Docket No. 50-395

SUBJECT: HUMAN FACTORS ENGINEERING CONTROL ROOM DESIGN REVIEW/AUDIT - SUMMER

HUMAN FACTORS ENGINEERING CONTROL ROOM
DESIGN REVIEW/AUDIT
V. C. SUMMER

4.2 H.V.A.C. PANEL

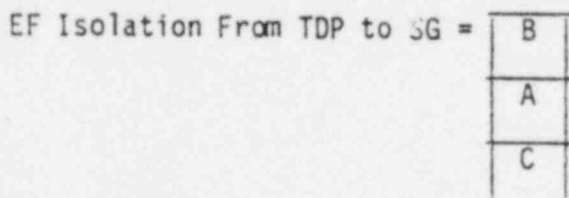
- a. Mimic is color coded but the coding is not carried out over the controls and the panels (Category 2).
- b. Damper Controls and Mimic for LOOP A, LOOP B, TRAIN A, TRAIN B, do not appear to correspond. Cannot tell on the mimic what is a loop or what is a train. The control labeling is very confusing and not apparent on the mimic (Category 2).
- c. There are large numbers of fan controls grouped together and it is not easy to find a particular fan by number. Also, the arrangement of those controls does not correspond to their relative position on the mimic (Category 2).

- d. Considerable glare on mimic, particularly at the top of HVAC panel (Category 2).
- e. Mimic board is too high for a 5th percentile person to read (Category 3).
- f. CMC component identification numbers are hard to read when legend is not illuminated (Category 3).
